April 12, 2017

RE: RESPONSE TO REVIEW COMMENTS  
LOT 9, CUMBERLAND FORESIDE VILLAGE

CUMBERLAND FORESIDE VILLAGE LOT 9  
U.S. ROUTE ONE, CUMBERLAND, MAINE

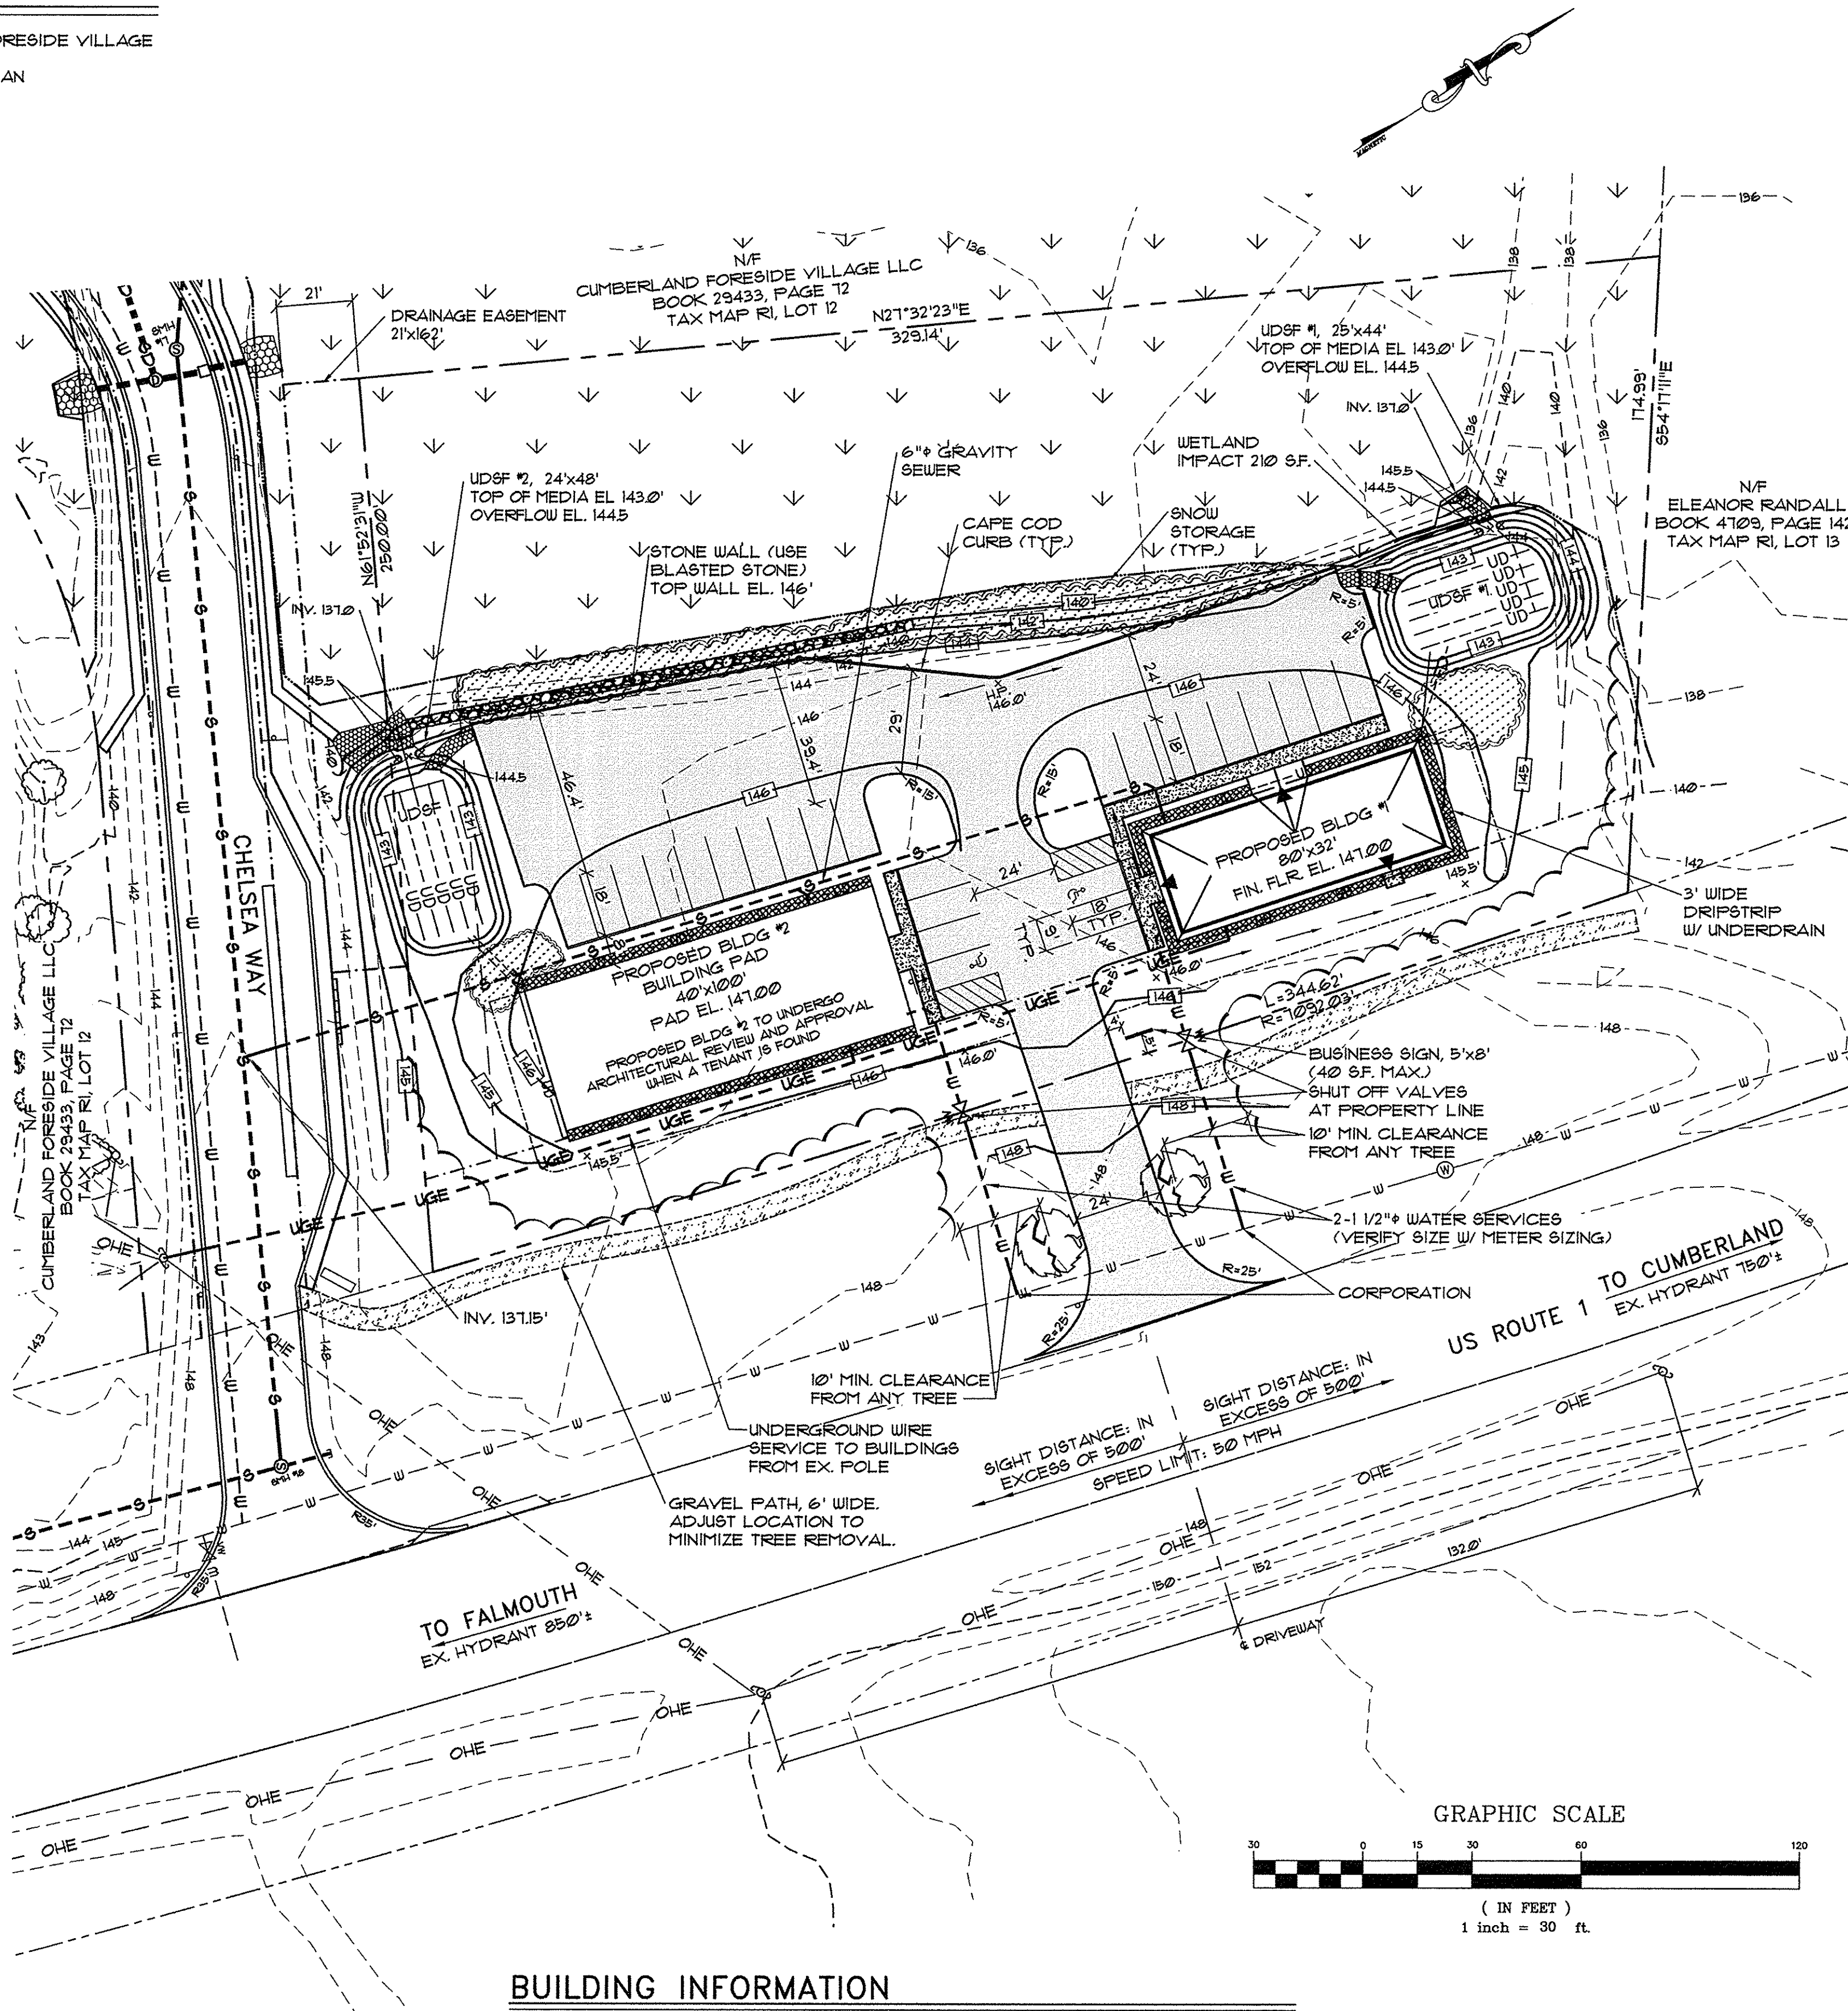
1. The roadway and parking dimensional data is shown on the Site Plan, Sheet C1.1.
2. General building information is shown in a chart on C1.1 including suggested building addresses. The entrance is a driveway, not a private way.

3. The traffic study included in the application materials is dated 8/29/16.
4. Note 19 is added to C1.1 outlining requirements to protect the Northern Long-Eared Bats population.

13. The recommended Conditions of Approval have been added to Sheet C1.1.
14. We note the second building pad will be for office use. We will return to the Board for Architectural review when the tenant is determined.

16. The Contract Zone setback requirements have been added to C1.1.
17. The 3<sup>rd</sup> Amended Subdivision Plan has been replaced by the 4<sup>th</sup> Amended Subdivision Plan and is included with this submission.

C1.2

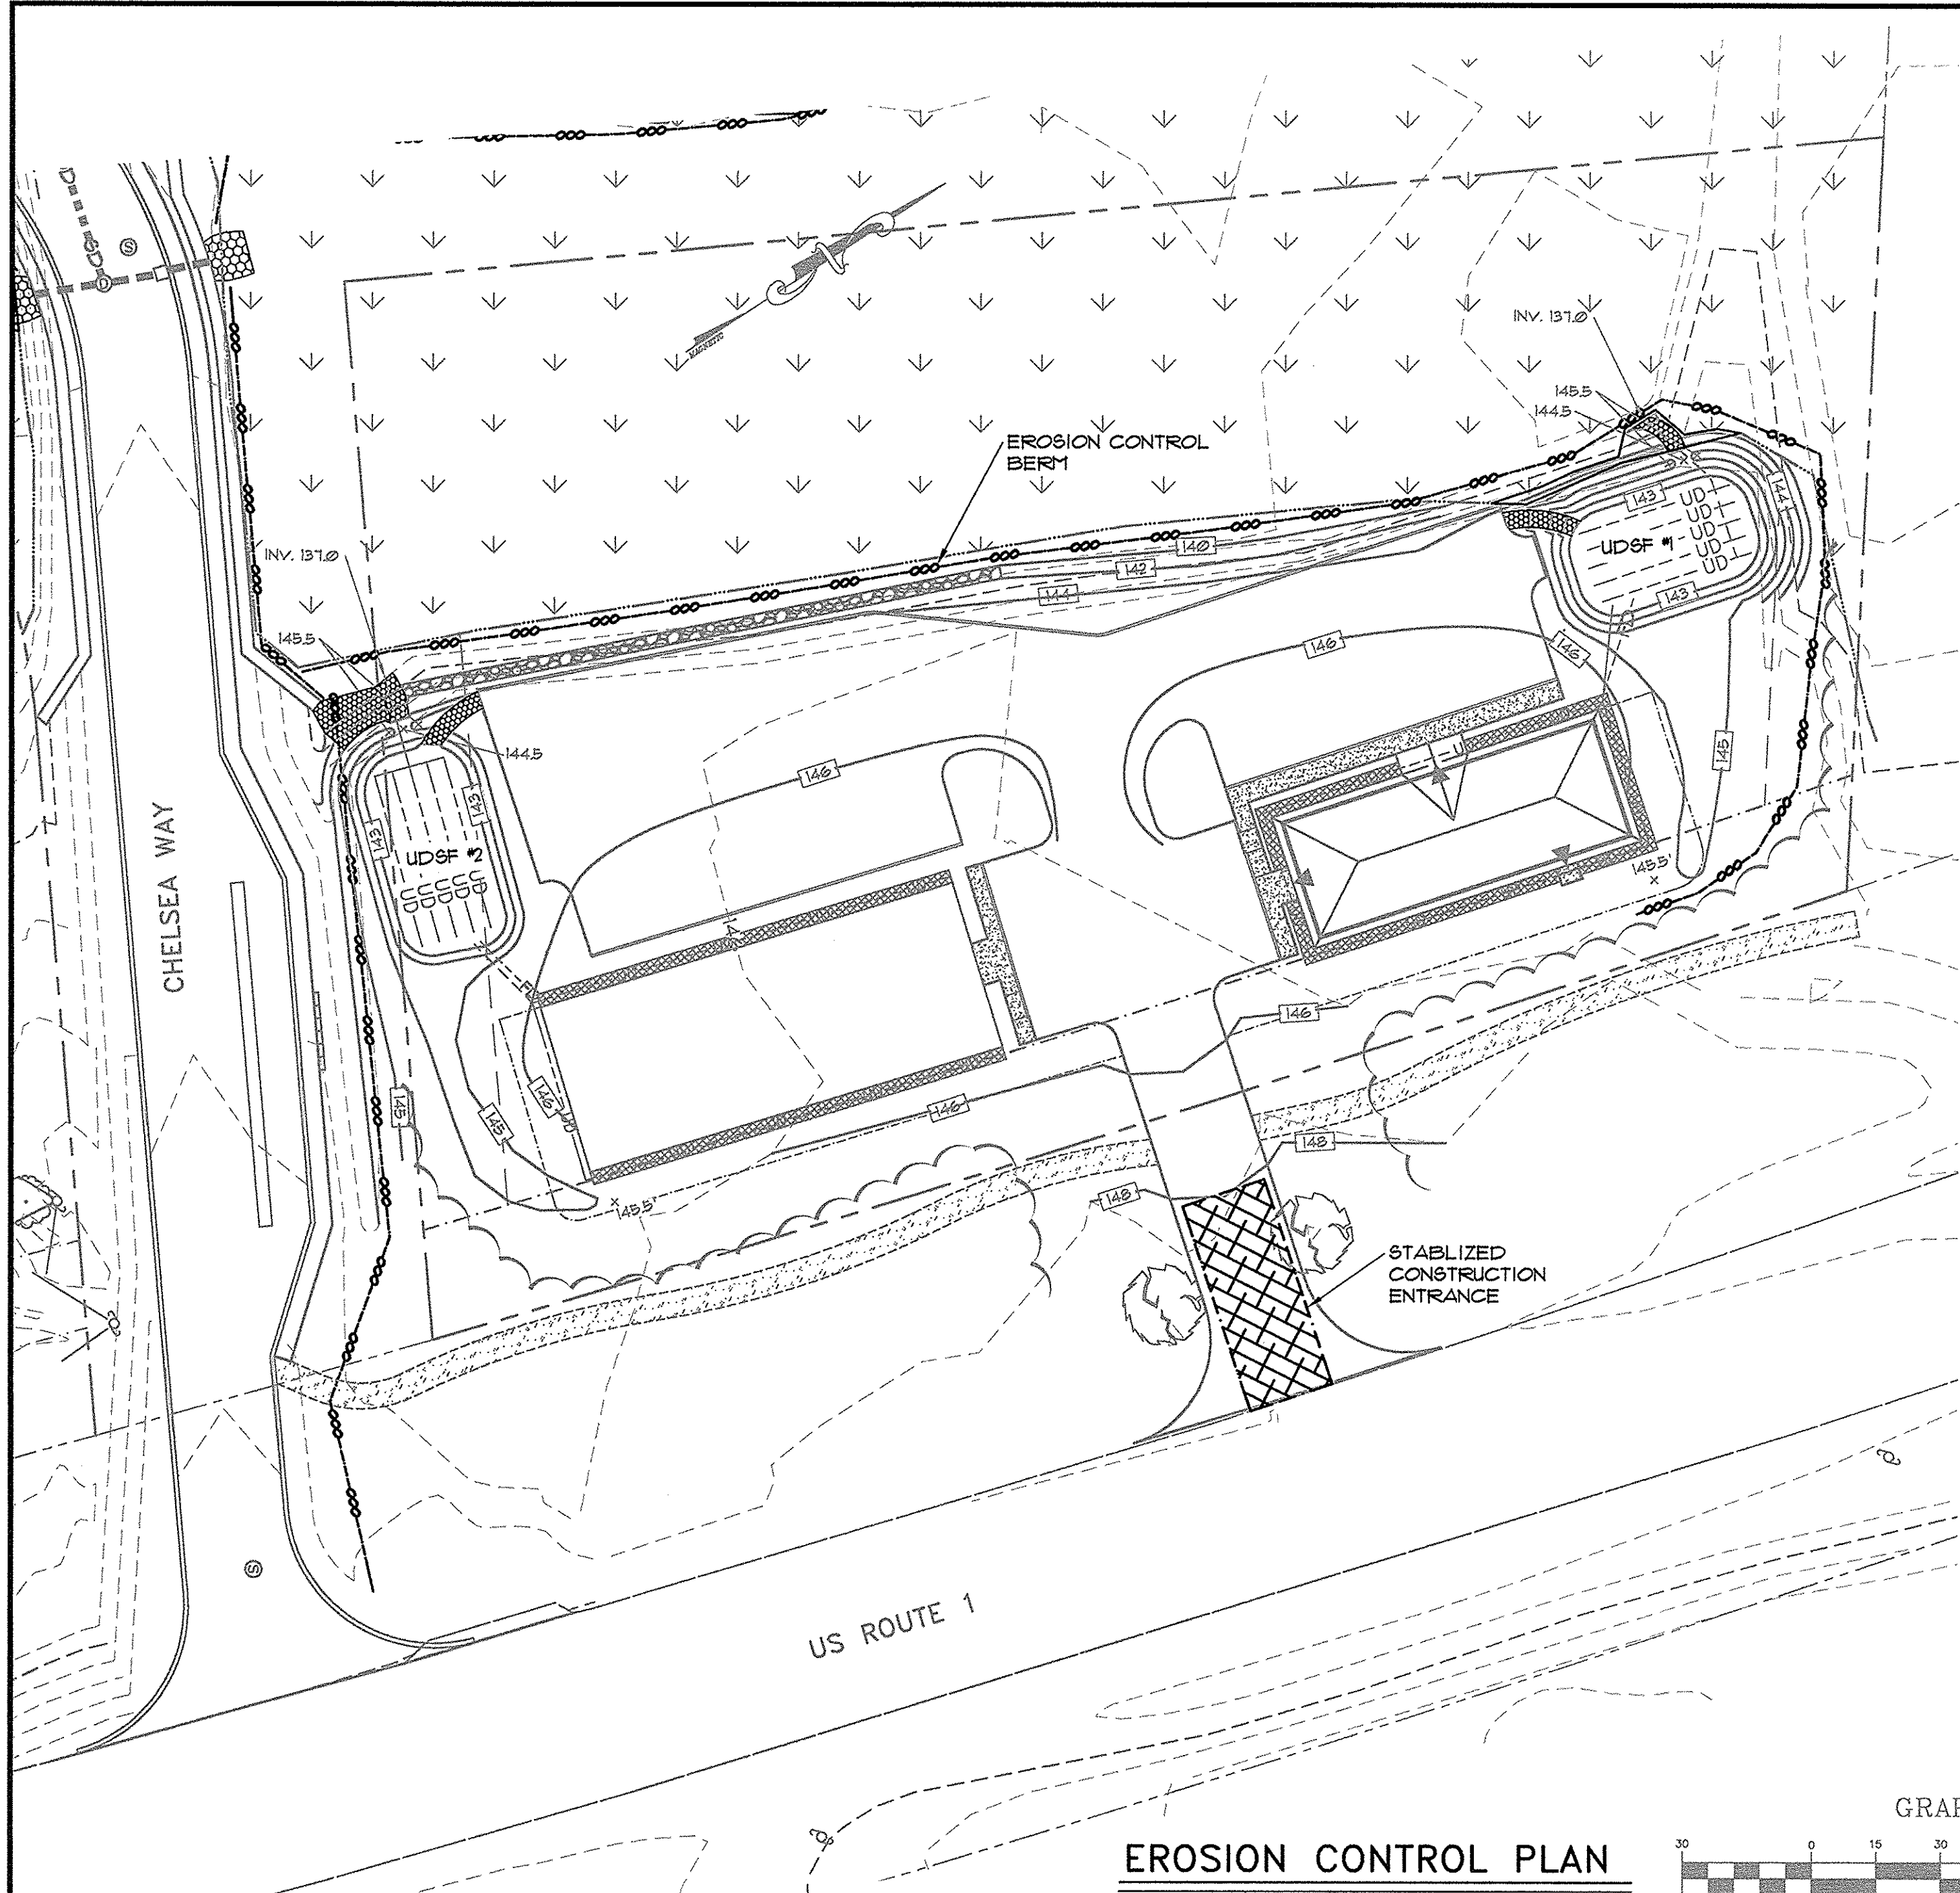
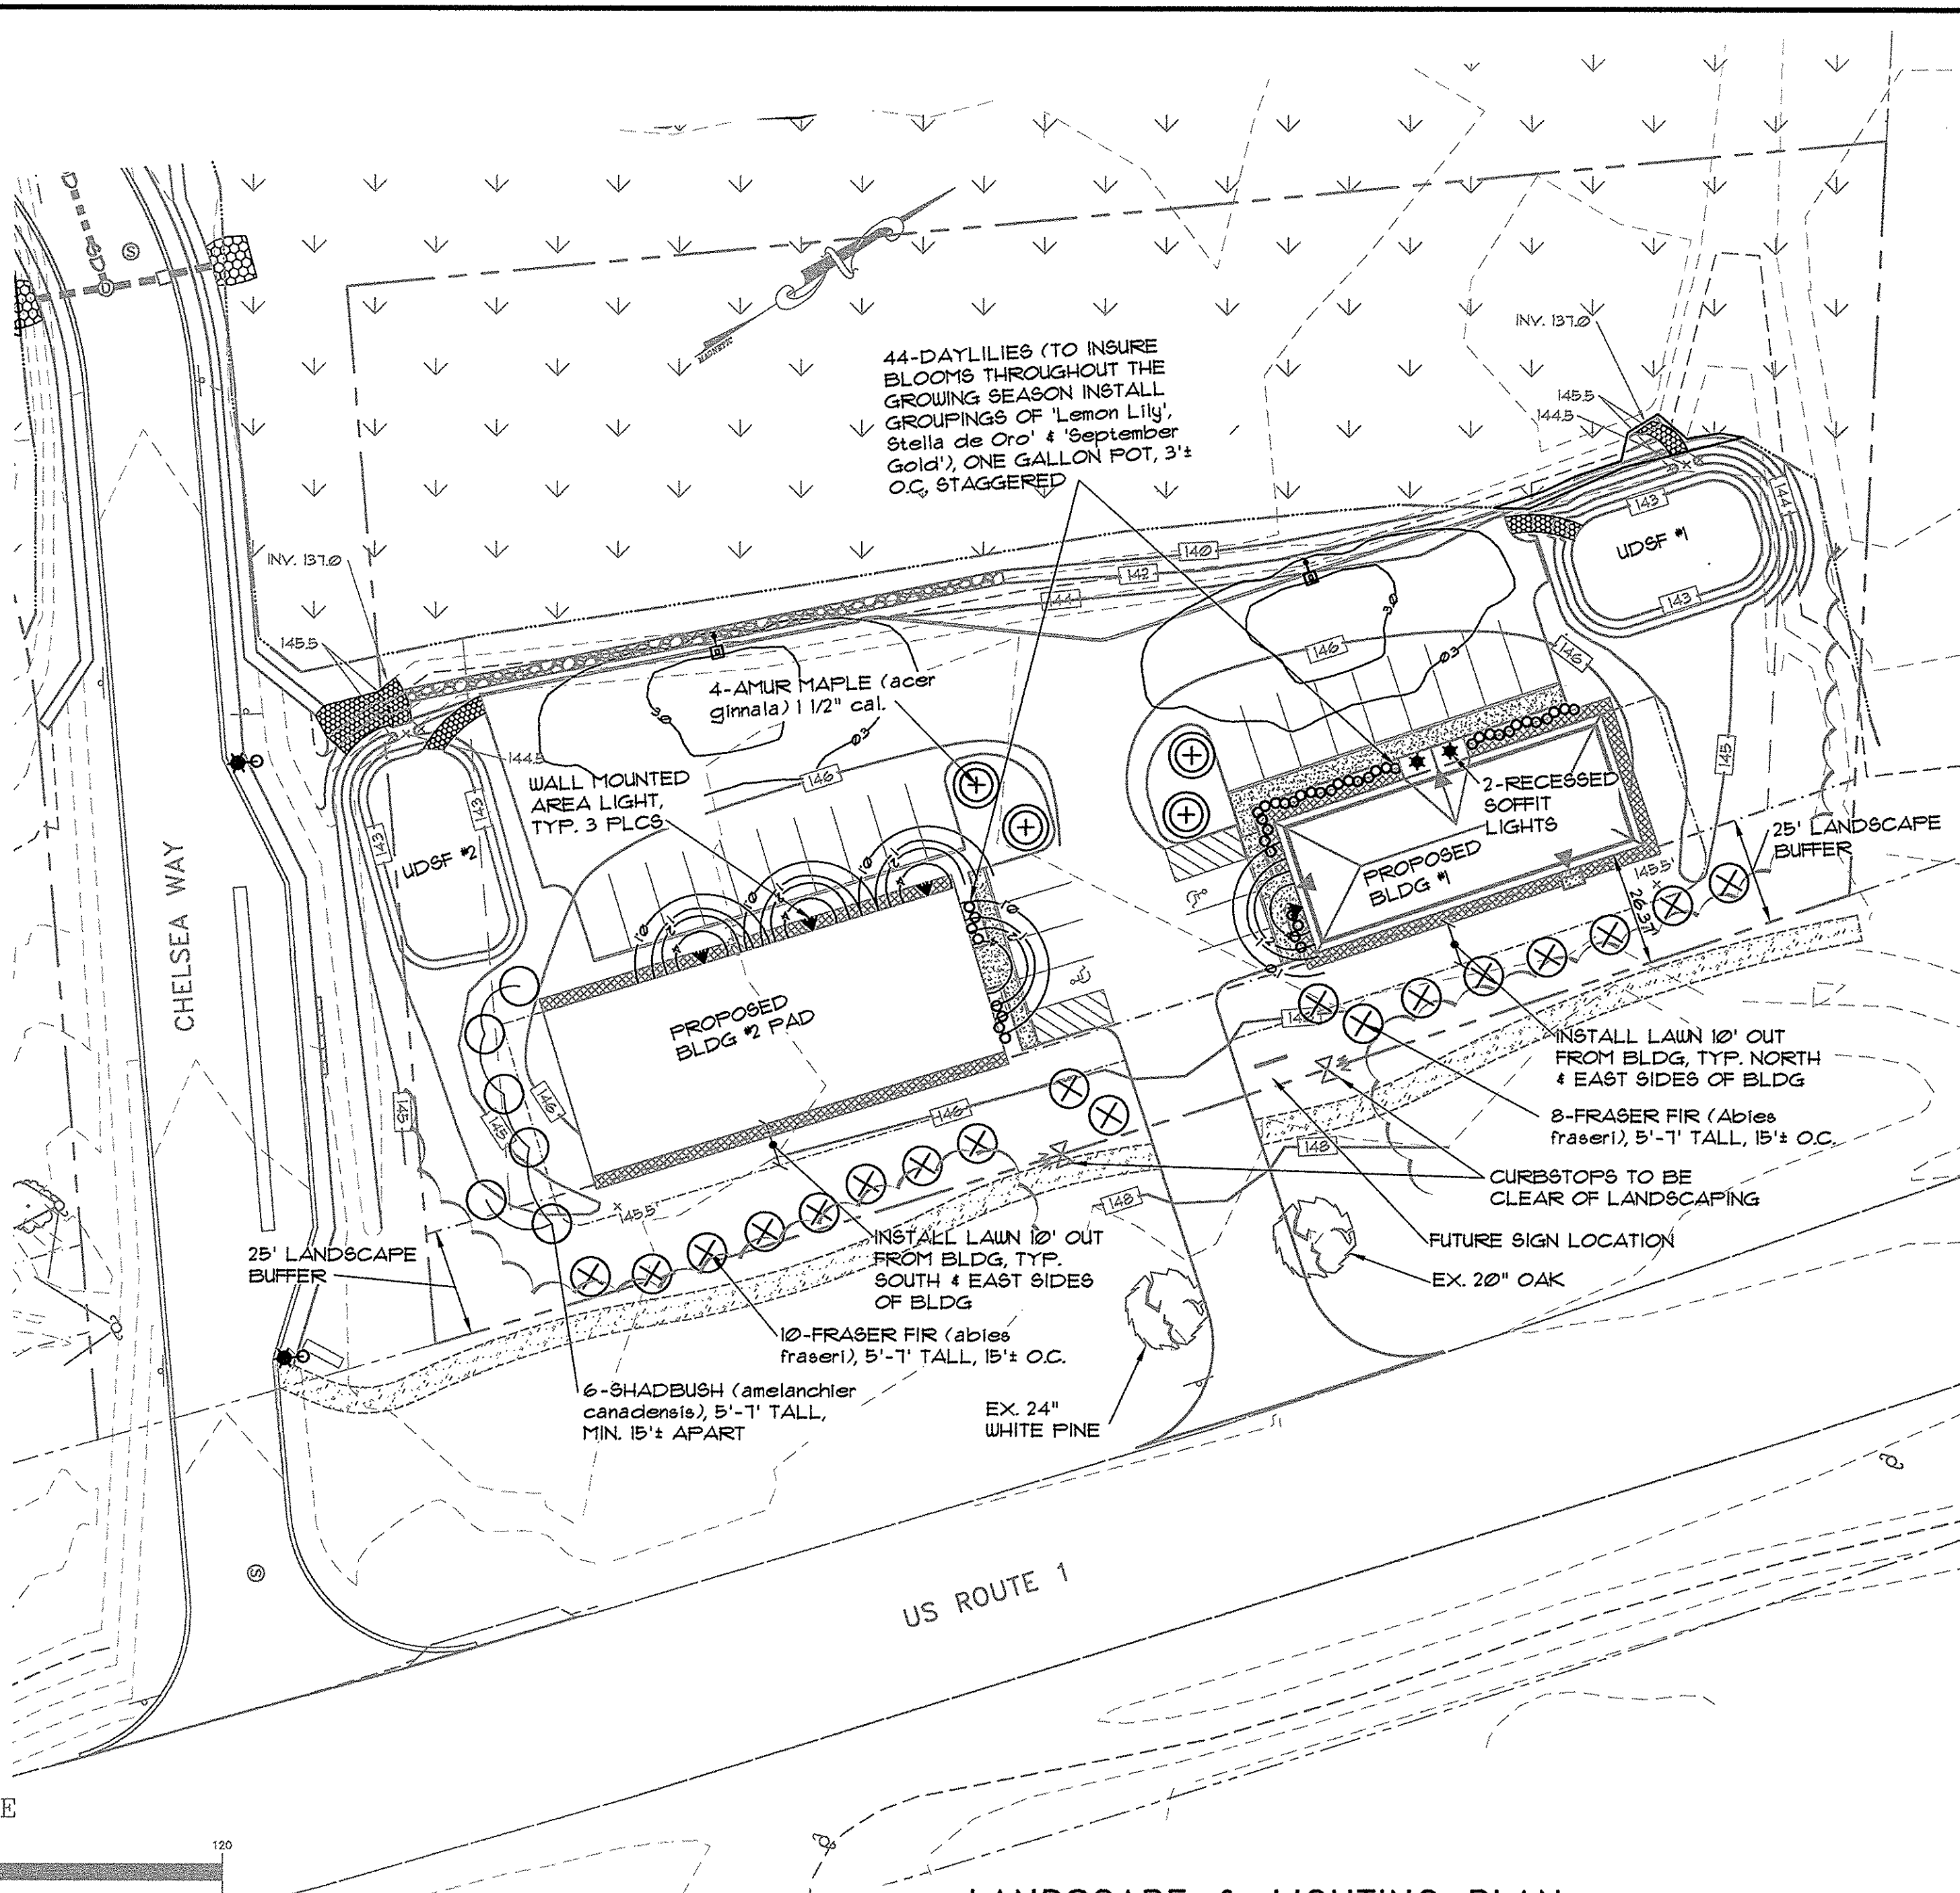
7. We have added pole lights to the back of the parking lot. See Sheet C1.2 for revised photometrics.
8. An updated letter of financial capacity is included in this submission.
